MONTGOMERY COUNTY HISTORIC PRESERVATION COMMISSION
STAFF REPORT

Address:	17 Hesketh St., Chevy Chase	Meeting Date:	1/23/18
Resource:	Contributing Resource Chevy Chase Village Historic District	Report Date:	1/17/18
Applicant:	Charlet Wang	Public Notice:	1/10/18
Review:	HAWP	Tax Credit:	n/a
Case Number:	35/13-18C	Staff:	Dan Bruechert
Proposal:	Building addition, accessory structure, and other alterations

STAFF RECOMMENDATION

FIRST FLOOR PLAN

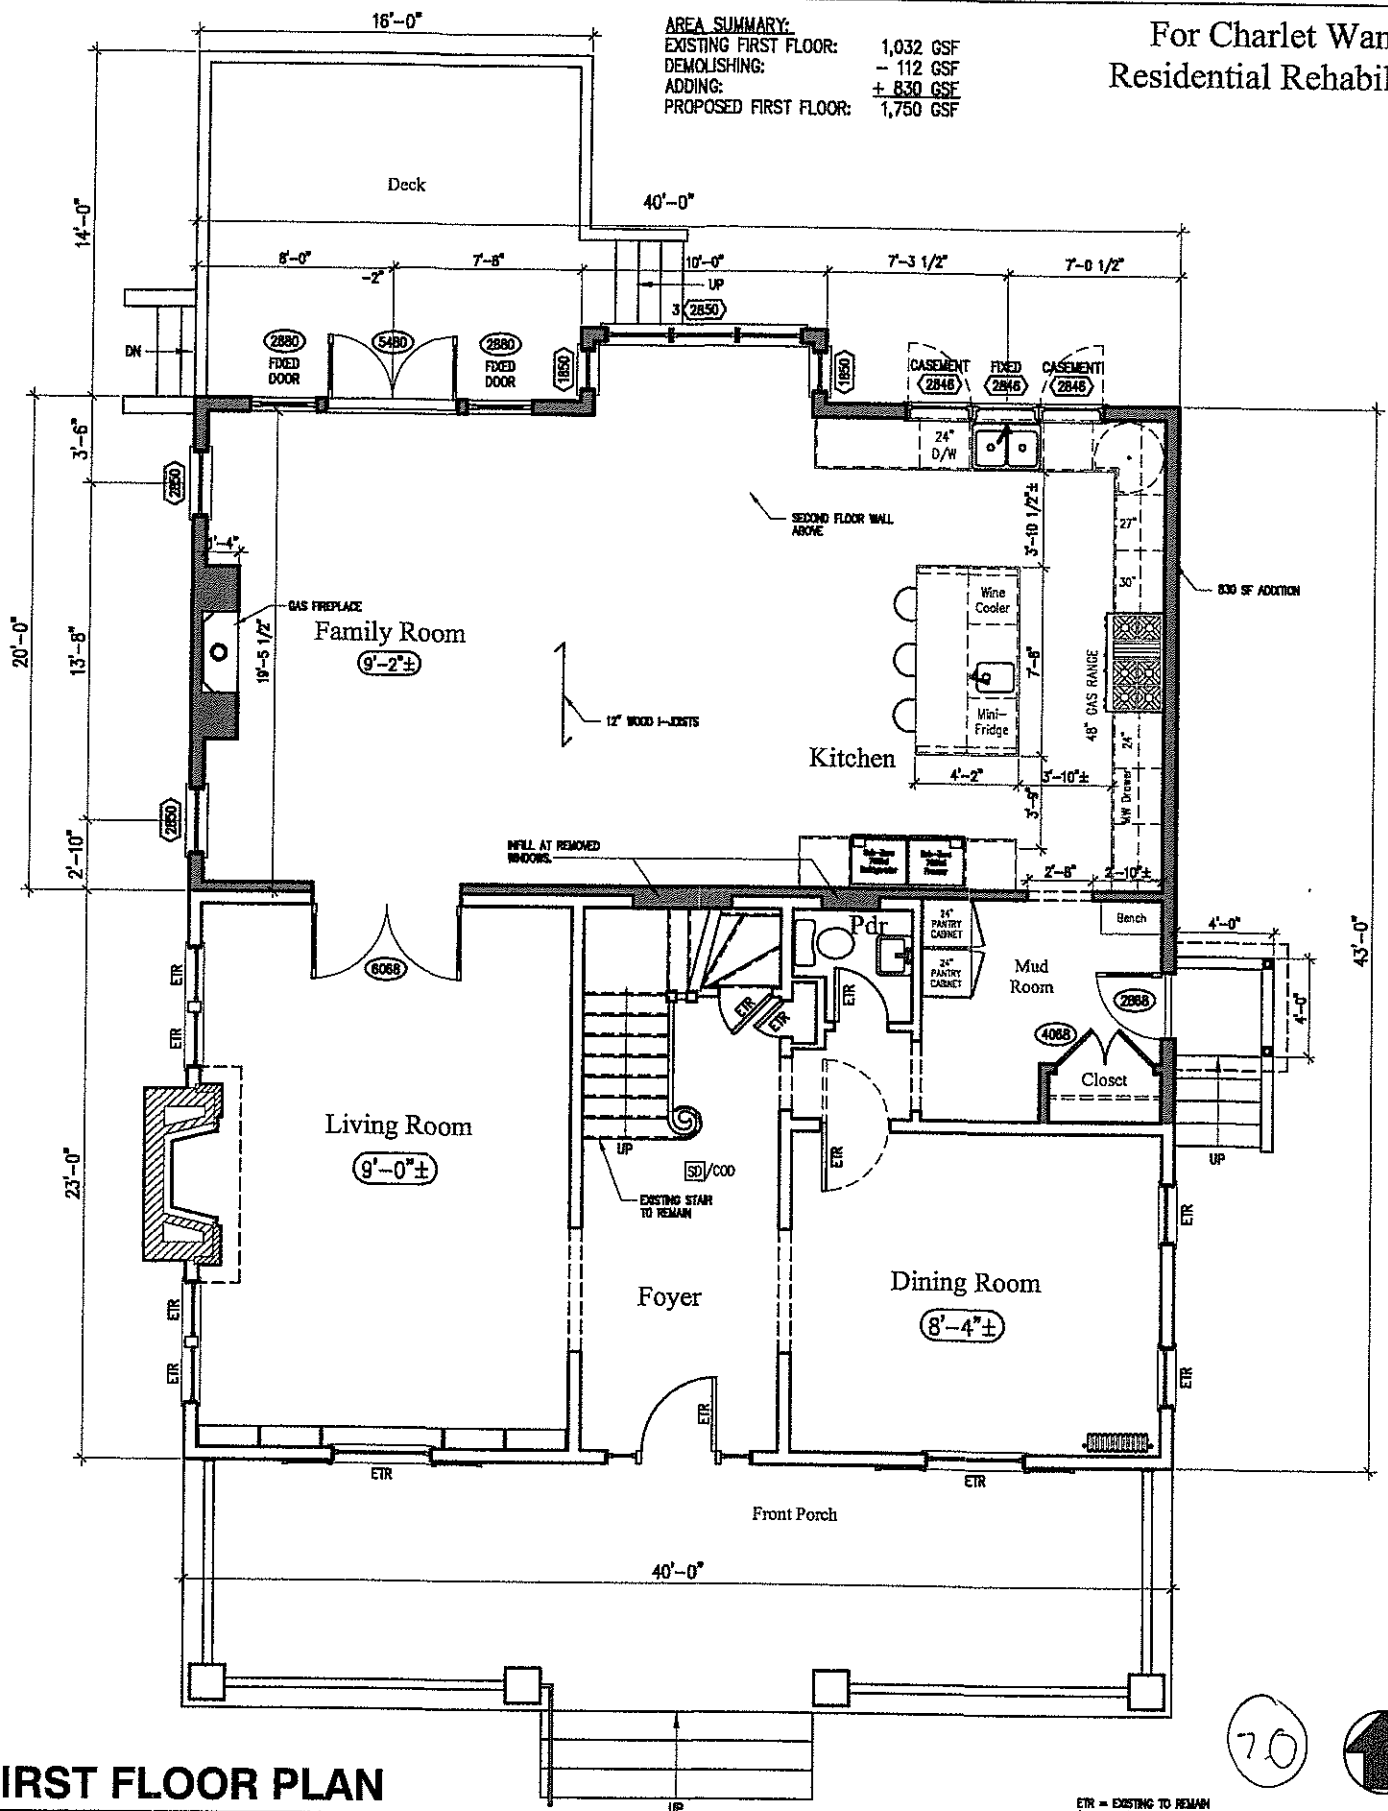
In place of the small addition, the applicant proposes to construct a 40' × 20' (forty feet by 20 feet) rear addition. This addition will extend to the wall planes of the historic house massing and will almost double the house footprint (the footprint of the historic house is 40' × 23'). The addition will be clad in Hardi siding with a 7" (seven inch) reveal with the smooth side facing out. The foundation will be red brick, which matches the exposed foundation on the rear of the house. The roof will be a rear-facing gable, with the addition's ridgeline set below the ridge of the historic side-facing gable. The roof will be covered in asphalt architectural shingles to match the existing shingles. The applicant proposes to use an Anderson 200 Series Vinyl-Clad windows, mostly in a six-over-one lite pattern. The applicant also proposes to use several four-over-one sash windows, in addition to several multi-lite French doors and three single-pane casement windows.

Staff finds that while the size of the addition is significant, it is not inconsistent with the size and scale found throughout the Chevy Chase Village Historic District. The roof cornice will carry through to the addition and create a uniform element that draws the two portions of the building together. This proposal would create a 43' (forty-three feet) deep, uninterrupted, wall plane. Staff believes that this new expanse would create an appearance that is inconsistent with the design of the historic house would negatively impact the integrity of the contributing structure (per the Chevy Chase Village *Design Guidelines*). As is common practice with rear additions, Staff recommends that the rear addition be inset from the historic wall plane by 12" (twelve inches) on each side. This relief creates a clearer division between the new and historic construction, and it will break up the massing of the side of the house, lessening its impact on the surrounding district. This inset will also reduce the visibility of the first floor of the right side of the addition, which has no windows.

1. The proposed addition must be inset by at least 12” (twelve inches) on each side from the wall plane of the historic house.
2. The material appearance and profiles of the proposed new windows must be submitted for review and approval, with final approval authority delegated to Staff. If Staff determines the material is not acceptable an aluminum clad window in the proposed configuration is acceptable.
3. The windows must have fixed exterior and interior grilles.
4. The door and railing for the proposed new side entrance must be submitted for review and approval with final approval authority delegated to Staff.

PROPOSED RIGHT ELEVATION

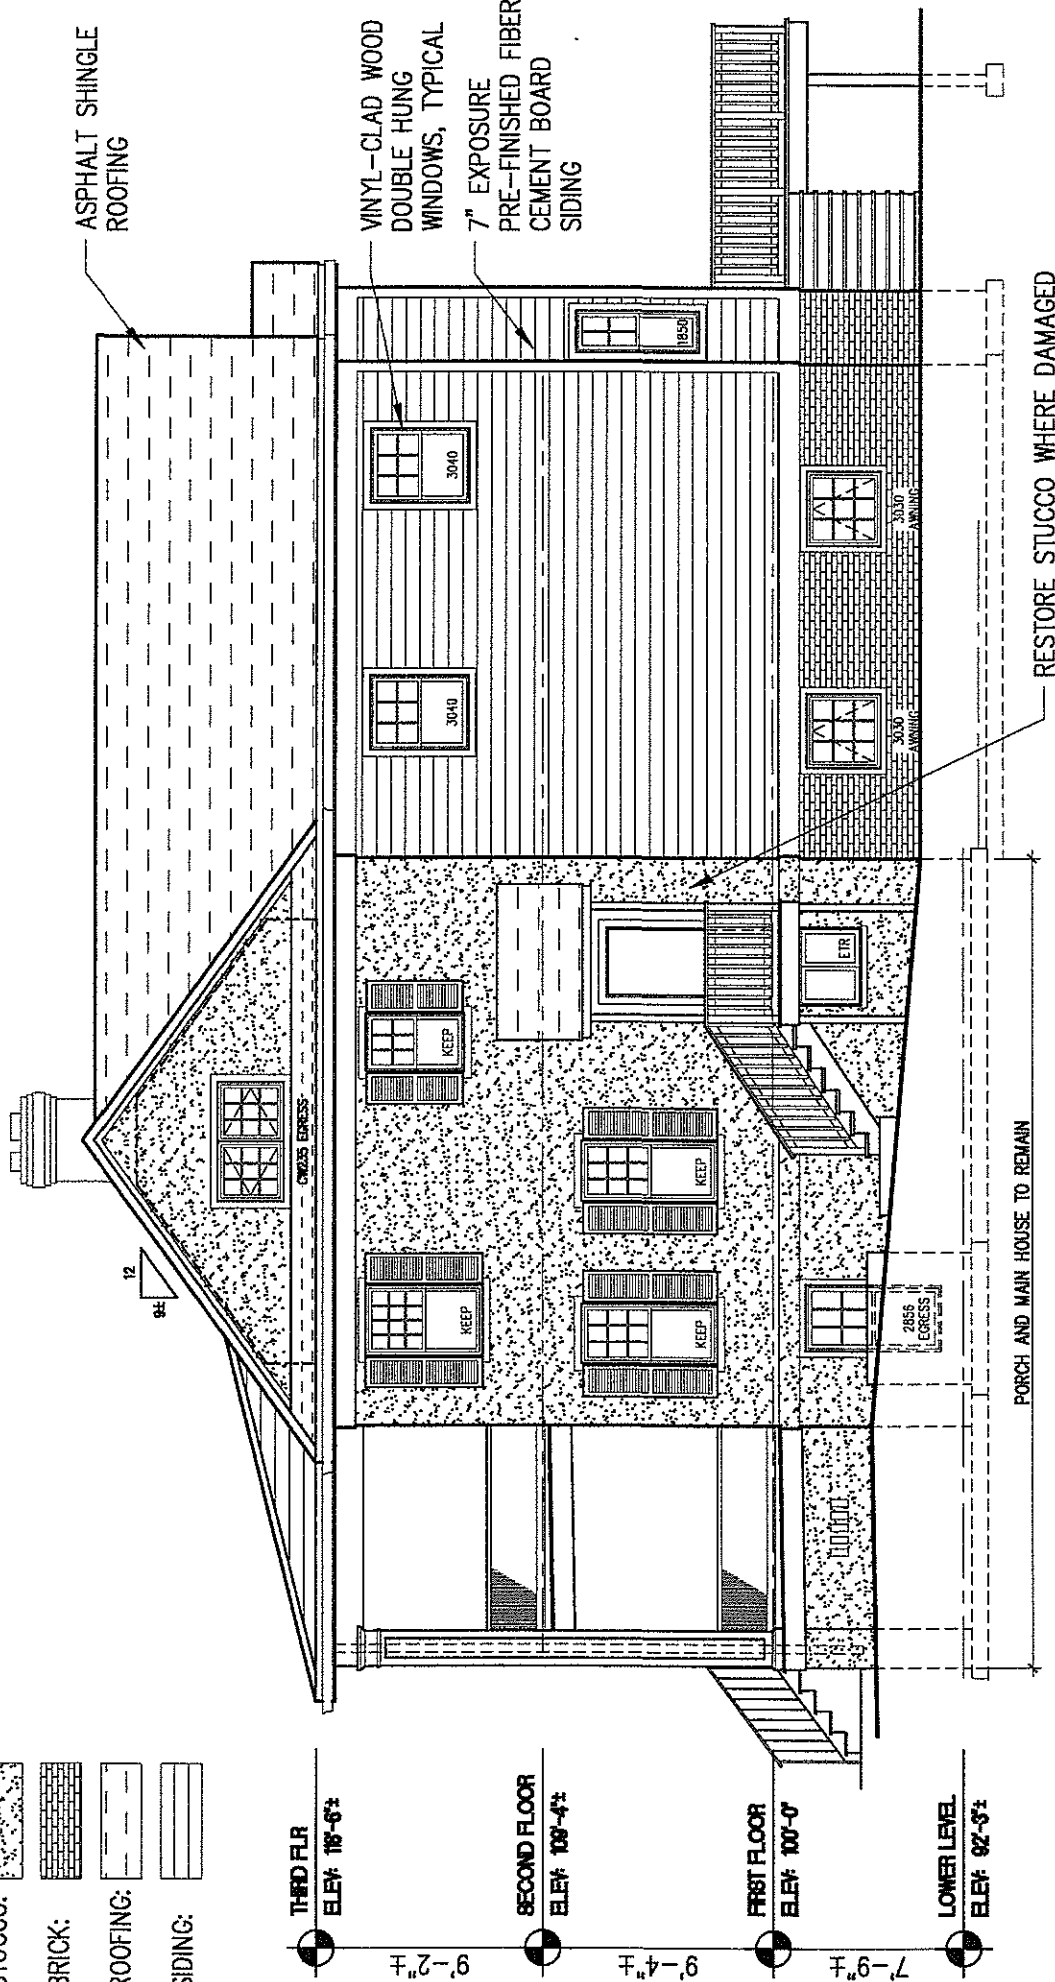
The applicants propose to construct a new side entrance into the right side of the historic house. This proposed change will remove the third window back from the front on the right side (an eight-over-one sash) and replace it with a door. The door will be accessed by a set of wood steps with a wood railing and landing. A shed roof with Hardi siding, matching the addition, and architectural shingles will provide some protection from the elements.

While the applicant has not provided adequate details for the railing or the replacement door, Staff believes that this new entrance is, when viewed under ‘moderate scrutiny,’ an acceptable alteration to the building and that the building will still contribute to the character of the surrounding district. The simple details of this new feature will not compete with the architectural composition of the historic house. Staff supports the approval of this new entrance, but recommends conditioning the approval on the review of the railing and door, with final approval delegated to staff.

PROPOSED REAR ELEVATION

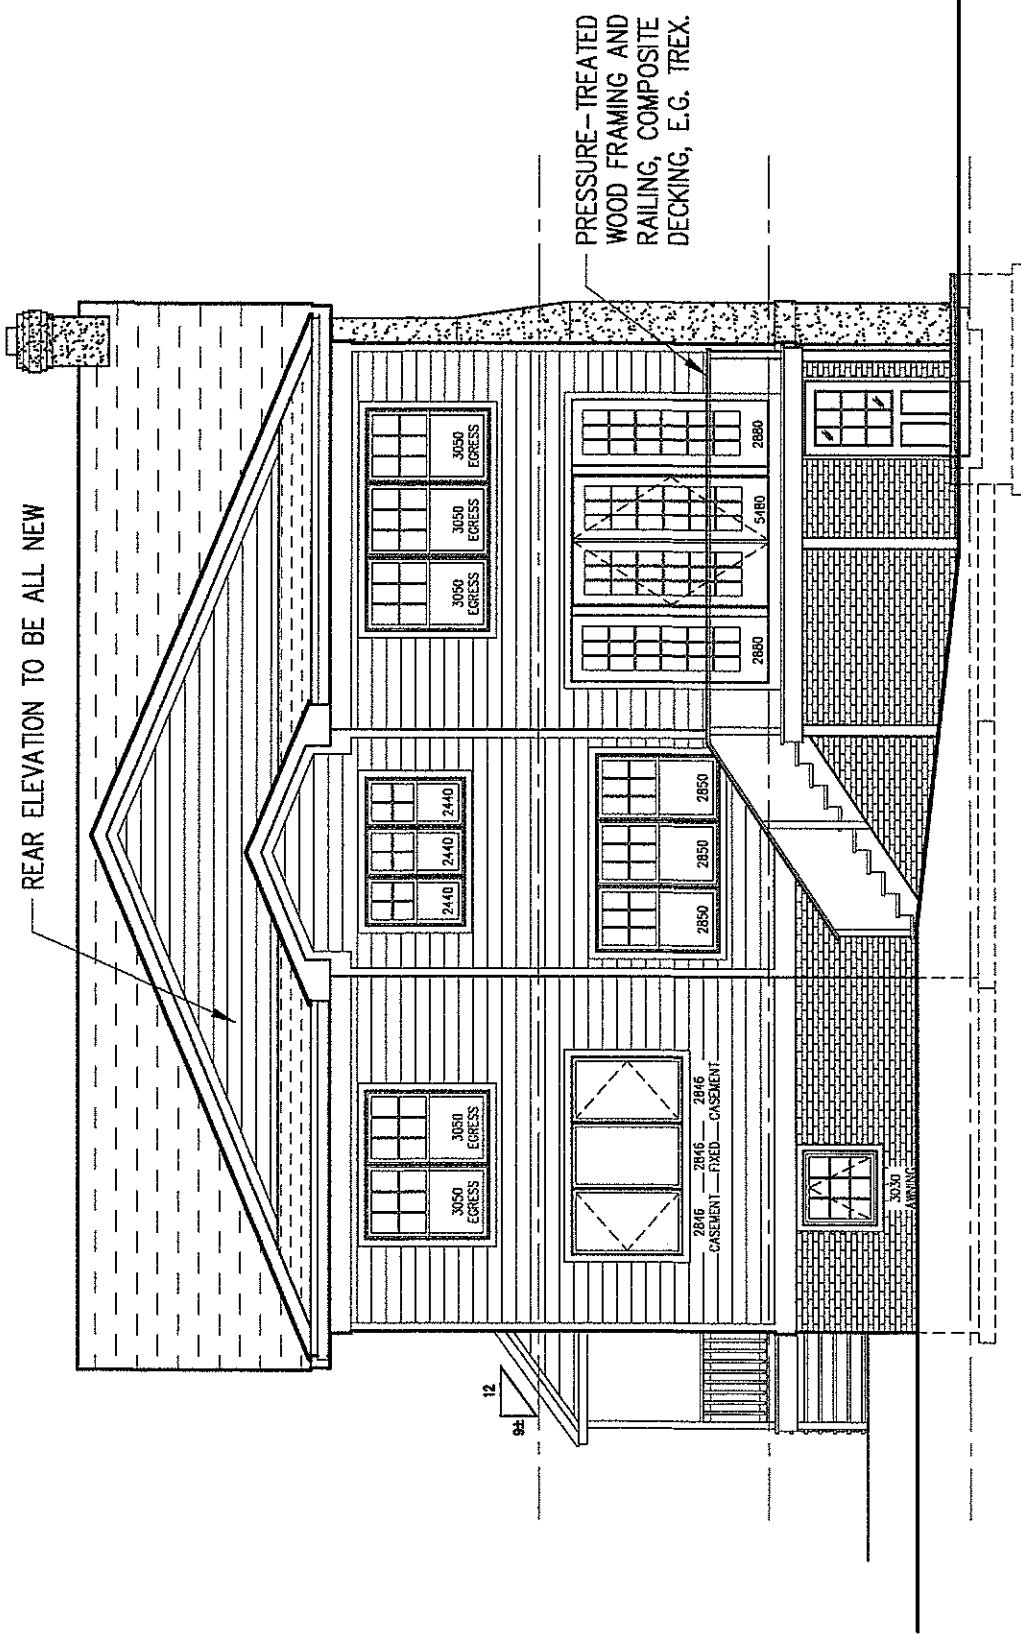
The applicant proposes to construct a new 12' × 17' (twelve feet by seventeen feet) deck to the rear of the house. This deck will be constructed out of wood and will match the design of the existing rear deck. Due to the change in slope and its placement behind the new addition, this deck will not be visible from the public right-of-way. The *Design Guidelines* state that alterations to the rear of a resource should be approved as a matter of course. This new deck will not detract from the historic resource or the surrounding district and staff supports its approval.
